Historical Architectural Review Board
COA Preliminary Review Sheet

HDC-2025-00008

Address: 1528 Linden Street

Proposal: Violation correction - Vertical platform lift installation with landing infill and railings.

Top Landing (Applicant)

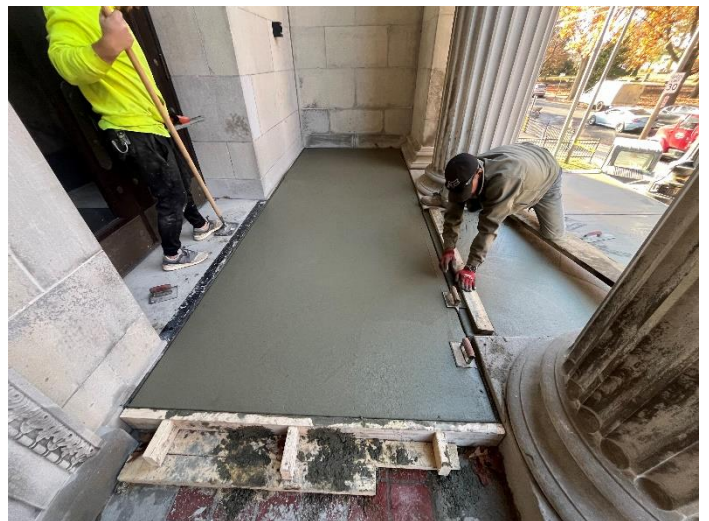
The Guidelines recommend considering provisions for reversibility so that modifications can be easily removed without damaging historic fabric in the future. It appears in the photos that concrete was built up over the existing stairs and tiled entryway. Any future removal of this concrete may compromise the integrity of the historic materials.

The new railings at the top landing are similar to the existing stair railings in materiality and finish but appear to have a different profile.

Proposed Lift (Applicant)

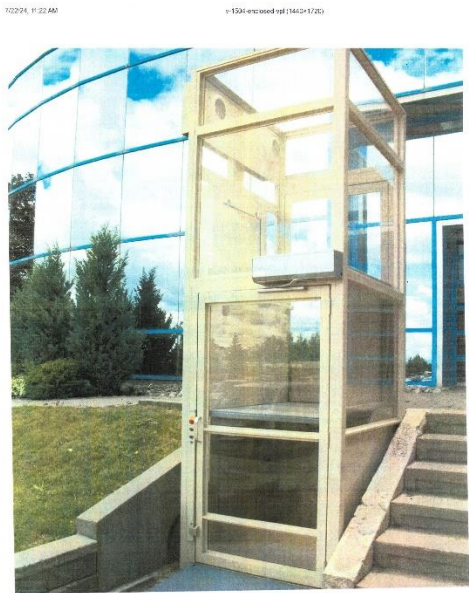
Information has been submitted regarding the configuration of the lift. The metal components in the sample image appears to be a buff color. A color that complements the existing surrounding stone would be appropriate. It would be helpful for the applicant to confirm the intended finish color of the lift.
